Access Compliance Report

Public Rights-of-Way

Intersection ID: 10031762	Main Street: MIDWAY_PARK_DR	Cross Street: N/A	Location: W
ADA ID: 985652AD9061	Ramp Type: BlendTrans1	Initial Pass/Fail: Pass	Overall Compliance: No
		Severity Score: 30

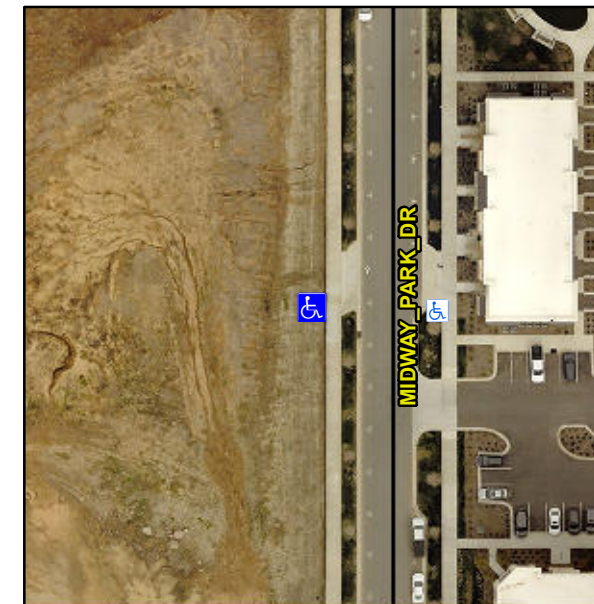
ACCESS AISLE RAMP

R304.2.2-Perp, R304.3.2-Para, R304.2.3, R305, R302.7.2, R304.5.3

Remove & Replace Curb Ramp With Two New Directional Ramps or Equivalent. Remove & Replace Gutter.
